Lower Thames Crossing

9.69 Draft Statement of Common Ground between (1) National Highways and (2) Harlex Haulage and (3) J & B Martin (Crayford & Fawkham) Limited (Clean version)

**DATE: November 2023
DEADLINE: 7**

Planning Inspectorate Scheme Ref: TR010032
Examination Document Ref: TR010032/EXAM/9.69

Appendix B Harlex Vehicle Tracking

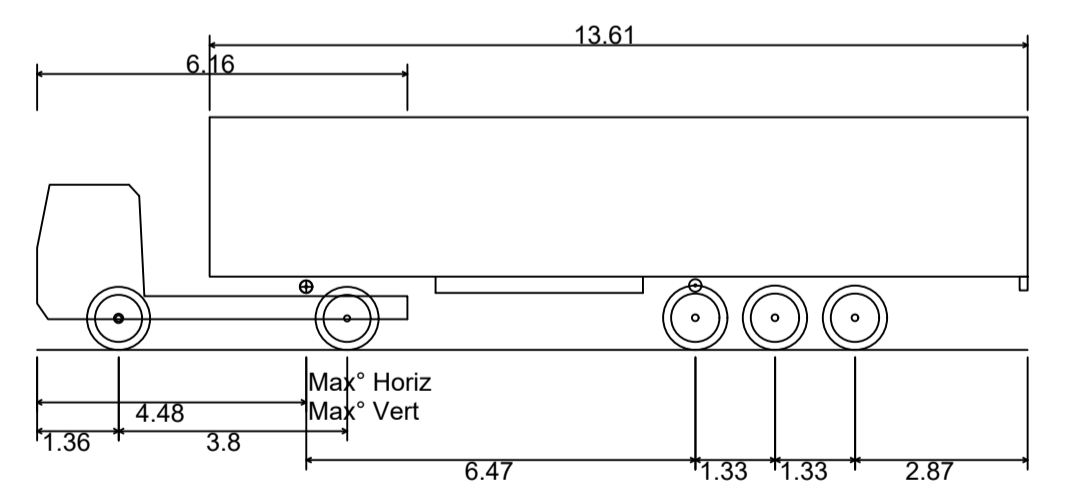
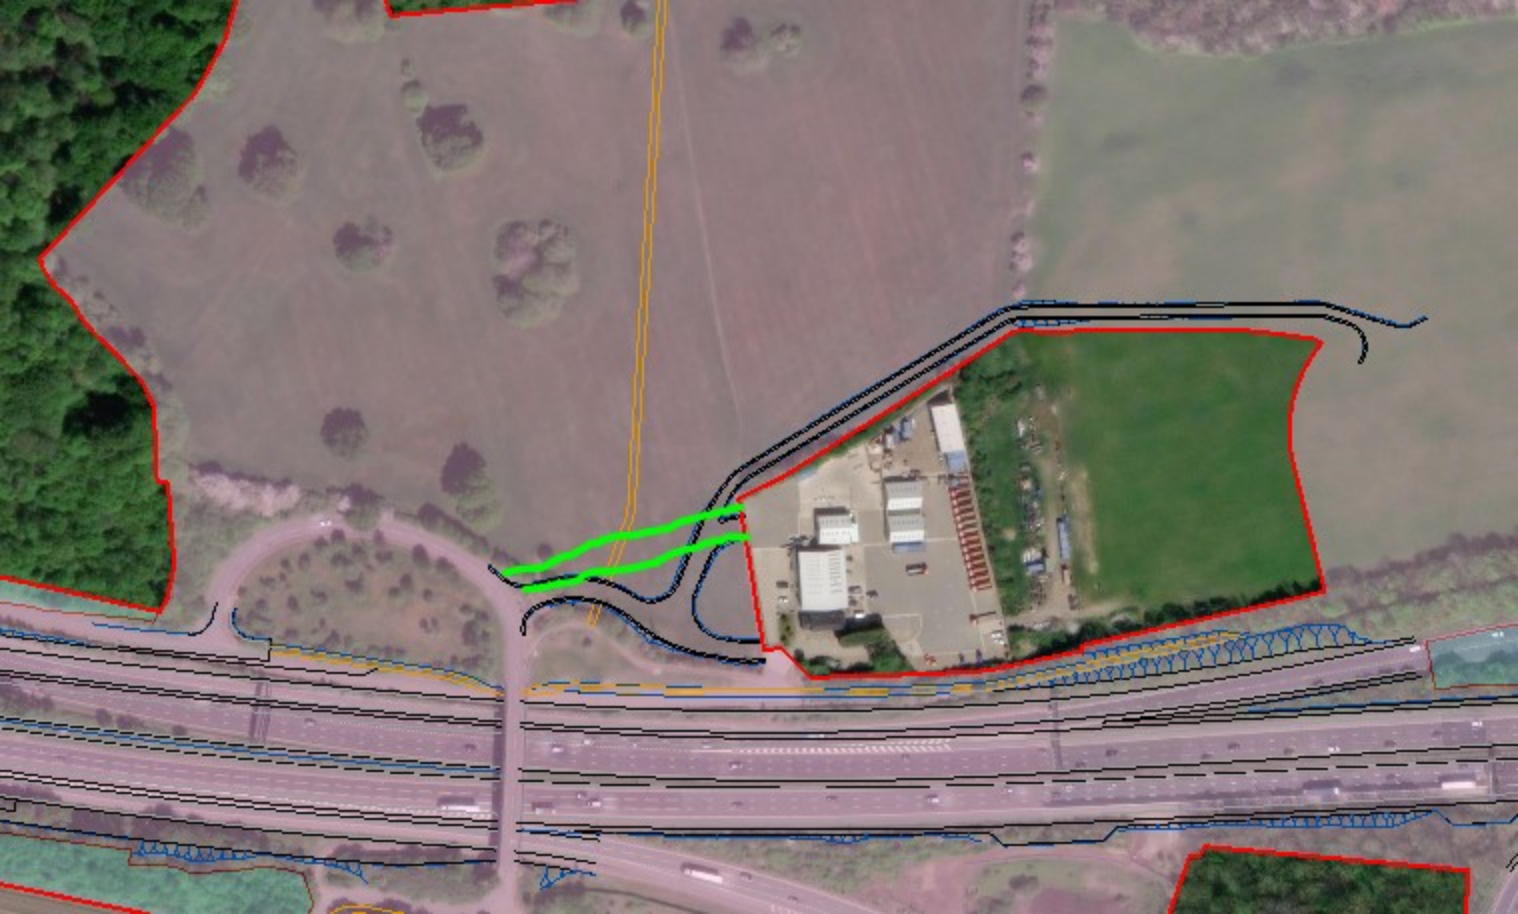
Topic	Item No.	Harlex Haulage Limited, and J & B Martin (Crayford & Fawkham) Limited Comment	The Applicant’s Response	Application Document Reference	Status
		<p>The interested party remains sceptical the sweep paths and vehicle tracking will work in practice from Park Pale Road and into the haulage yard</p>	<p>measuring 15.5m in length, can navigate the replacement access in its current design. Please refer to Appendix B.</p> <p>This further request to change the design, as illustrated in Appendix C, received on 7 February 2023, will have many impacts and the Applicant has a number of design concerns over the design of the access proposed by Harlex. Splitting the carriageway until the junction will lead to vehicles entering and exiting the junction on the wrong side of the road (as Harlex switch their direction of one way operation), which would be a safety risk. The current design ensures that all vehicles are on the correct side of the carriageway at the junction. As the access will also be used by the Applicant for maintenance of ponds, it would also mean that maintenance vehicles would either have to travel against the flow of traffic or go through the Harlex site to avoid conflict. Splitting the carriageway also means pedestrians using the footpath will have to cross two carriageways which is avoided in the current proposal. It may also need to be consulted on and will incur additional cost (compared to current design) and introduce consultation uncertainty.</p>

Topic	Item No.	Harlex Haulage Limited, and J & B Martin (Crayford & Fawkham) Limited Comment	The Applicant’s Response	Application Document Reference	Status
			<p>The replacement access to Harlex Haulage is a private/maintenance access track; therefore, it does not fall under the requirements of the Design Manual for Roads and Bridges (DMRB). However, to promote a conservative design approach at this stage of preliminary design, DMRB CD 123 recommendation at clause 5.2 has been considered: <i>“Allowance shall be made for the swept turning paths of the worst case design vehicle which is expected to use the priority junction.”</i></p> <p>The worst case scenario was not available at the time of the design; therefore, a standard design vehicle has been used in accordance with DMRB CD 123, which states: <i>“The design vehicle for at-grade priority and signal controlled junctions is a 16.5m long articulated Heavy Goods Vehicle.”</i></p> <p>As noted under clause 5.6.2 in DMRB CD 123: <i>“At simple priority junctions where provision is made for the design vehicle, the corner radii should be 15 metres in</i></p>

Topic	Item No.	Harlex Haulage Limited, and J & B Martin (Crayford & Fawkham) Limited Comment	The Applicant’s Response	Application Document Reference	Status
			<p><i>rural areas followed by a corner taper of 1:10 over a distance of 25 metres.”</i></p> <p>The uses of this junction will be limited to Harlex Haulage and National Highways maintenance vehicles only. Members of the public and general road users should not be using this access; therefore, this is a private means of access. As this junction does not sit on the Strategic Road Network nor form a through route the design has been developed to safely fit within the surrounding constraints.</p> <p>With all the considerations above, it is therefore concluded that the design of the access to Harlex is safe and in line with good practice and current standards.</p>		
Replacement Access – Tie in works	2.1.4	<p>Harlex suggest there would be level issues with ensuring the new access ties into the site</p> <p>The previous draft proposals provided by the Applicant need to be updated and take account of the further meetings held since April 2021.</p>	<p>The Applicant’s design accommodation letter for the replacement access road specifically deals with this issue and mitigates disruption. This was issued on 1 April 2021 with subsequent reminders. The Applicant will update and recirculate the design accommodation letter for the landowner to sign and return so it can transfer the commitments therein to Contractors and an associated Project Manager lead to ensure compliance.</p>	N/A	Matter Under Discussion

Appendix D Park Pale Curb Profile

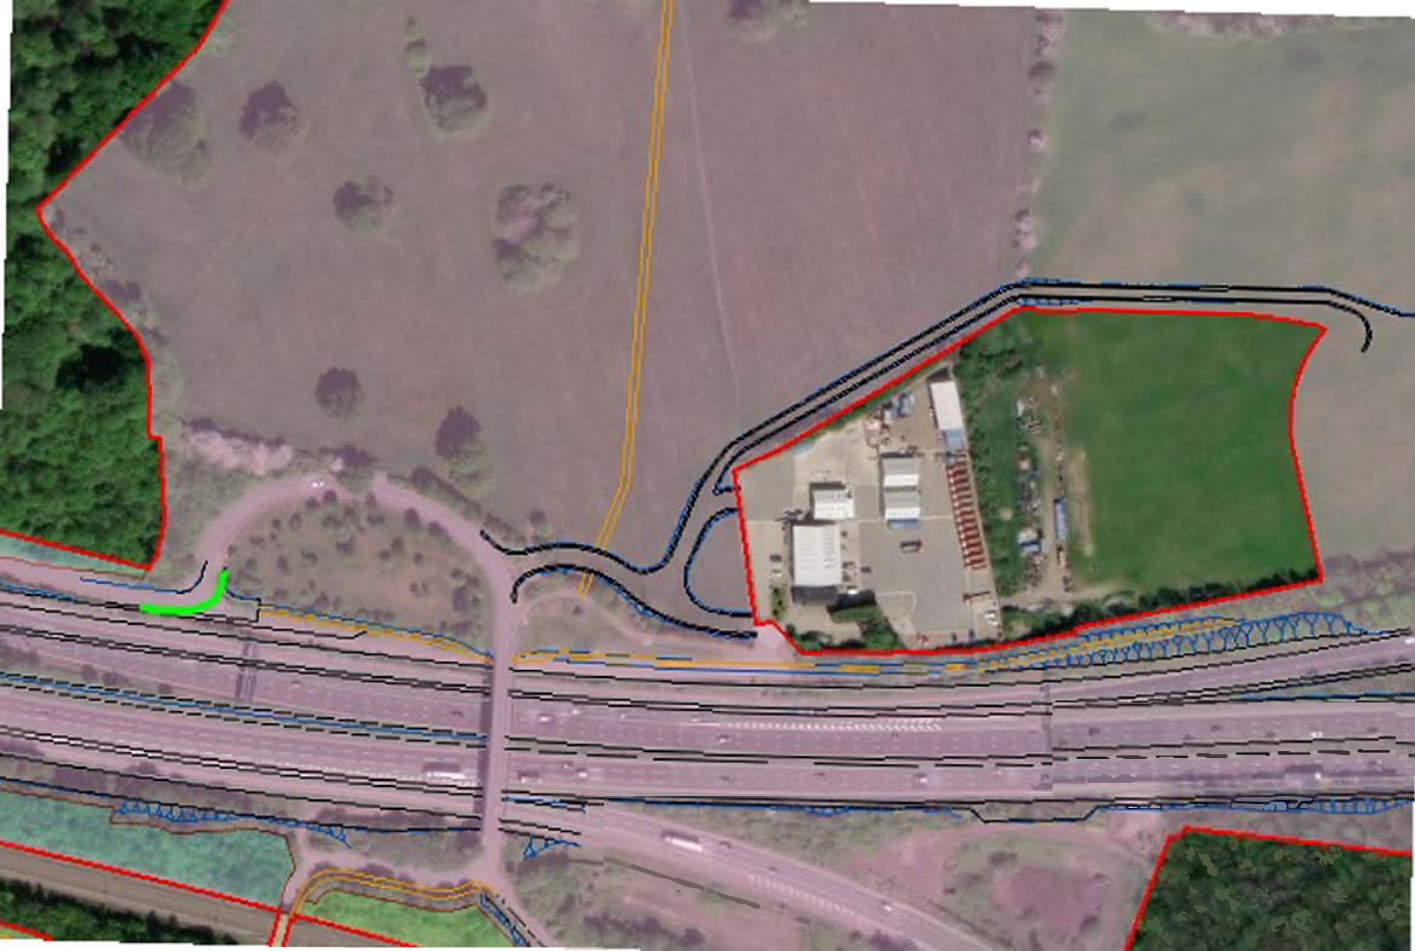
Park Pale curb profile	2.1.6	<p>Harlex have requested a continuous curb profile as Park Pale road diverts to provide access to the Harlex yard and the Golf Club to deter people parking and congregating in the T part .</p> <p>The interested party requires the Applicant to take responsibility for the consequences that will arise from the design changes of</p>	<p>The Applicant is willing to consider this request, dated 7 February 2023, to make the T junction a continuous curb profile as per previously circulated sketch, which can be seen in Appendix D. However, the Applicant would like to prompt Harlex to consider this request further. The current design allows vehicles to turn around on Park Pale before they get to the turn</p>	N/A	Matter Under Discussion

Topic	Item No.	Harlex Haulage Limited, and J & B Martin (Crayford & Fawkham) Limited Comment	The Applicant’s Response	Application Document Reference	Status
		<p>Park Pale Road (which is for access only) and agree with KCC Highways that better signage should be erected at the entrance to park Pale Road and also insist that both sides of the road are painted with double yellow lines.</p>	<p>heading to the overbridge. If this is removed, and a continuous curb profile is implemented, there is a risk that more vehicles could try and turn around in the carriageway causing more disruption to Harlex and road users.</p> <p>The Applicant requests confirmation from Harlex whether they want the Applicant to proceed with considering this design request through its governance process, in light of the above comments.</p> <p>The Applicant would like to emphasise that the DCO application as submitted contains sufficient provisions in which this curb profile request can be considered and accommodated at the detailed design stage, following consultation with all of the relevant parties (including Kent County Council as highway authority).</p> <p>In respect of Park Pale and traffic enforcement, the Applicant has relayed Harlex’s concerns to Kent County Council who are aware and will continue to monitor the issues presented by local landowners. Kent County Council advise Park Pale has an existing Traffic Regulation Order and signage has been</p>

Topic	Item No.	Harlex Haulage Limited, and J & B Martin (Crayford & Fawkham) Limited Comment	The Applicant’s Response	Application Document Reference	Status
			<p>renewed since the Applicant first relayed local landowner concerns. Kent County Council have also advised, by way of email dated July 2021, “In regards to including double yellow lines in the LTC proposals, we agreed it was not something that should be included as there is work underway to hopefully resolve the issue through other means and if it was deemed that double yellows were required, then KCC as the highway authority would look to install these”.</p> <p>The Applicant notes however that Part 3, Streets, article 10 of the draft DCO states:</p> <p>“Construction and maintenance of new, altered or diverted streets and other structures</p> <p>10.—(1) Subject to paragraphs (3) and (4), any highway (other than a trunk road or a special road) to be constructed under this Order must be completed to the reasonable satisfaction of the relevant local highway authority in whose area the highway lies and, unless otherwise agreed in writing with the relevant local</p>
